## Product Change Notice (PCN)

PCN Number: **PCN-0450984R-01**

Product(s) Affected: SJ1-3533N, SJ1-3534N, SJ1-3535N

PREVIOUS CUI DEVICES DETAIL / IMAGE	NEW CUI DEVICES DETAIL / IMAGE

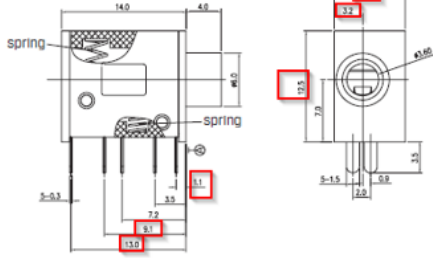
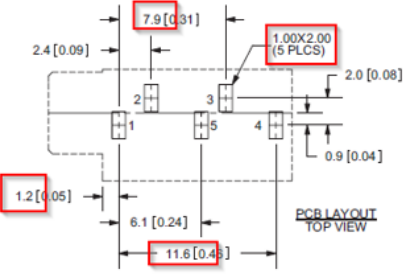
Description of Change: mechanical and material differences as shown below:

MATERIAL	PLATING
terminal 1	brass	tin
terminal 2	brass	tin
terminal 3	brass	tin
terminal 4	brass	tin
terminal 5	brass	tin
bushing	brass	nickel
spring	stainless steel	
plastic	PBT

DESCRIPTION	MATERIAL	PLATING/COLOR
terminal 1	brass t=0.30	silver
terminal 2	brass t=0.30	silver
terminal 3	brass t=0.30	silver
terminal 4	brass t=0.30	silver
terminal 5	brass t=0.30	silver
springs	stainless steel	
bushing	copper alloy (H59)	nickel
housing	PBT (UL94V-0)	black
cover	PBT (UL94V-0)	black
